Job Name: Orchard Park SS

Dust Collector Replacement

Submittal Drawings - Electrical

Project: Orchard Park Secondary School

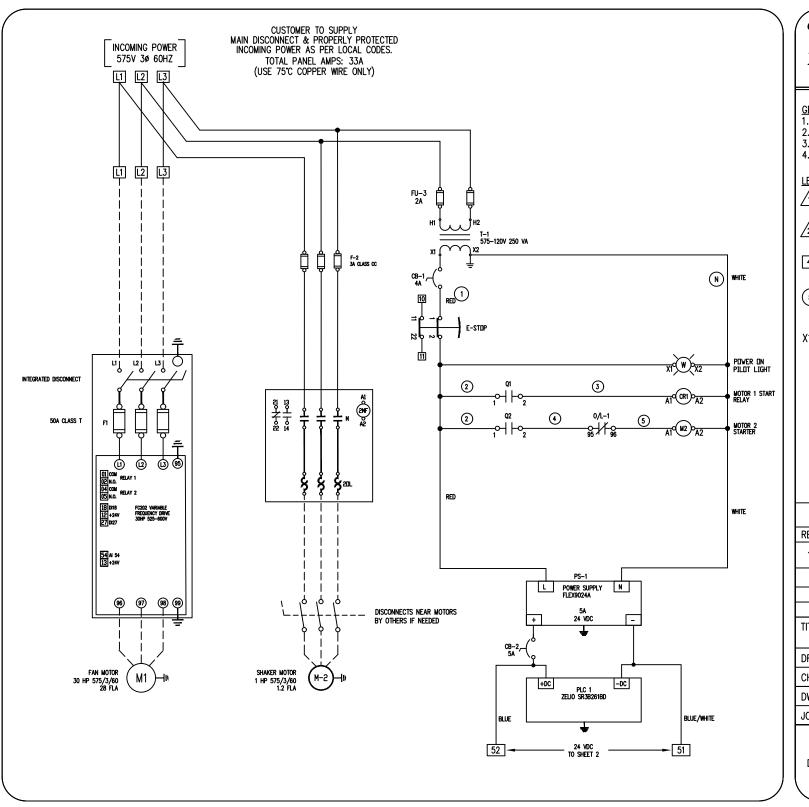
(GEI) SEE ENCLOSED COMMENTS.

(GEI) ELECTRICAL REQUIREMENTS TO BE REVIEWED BY ELECTRICAL ENGINEER.
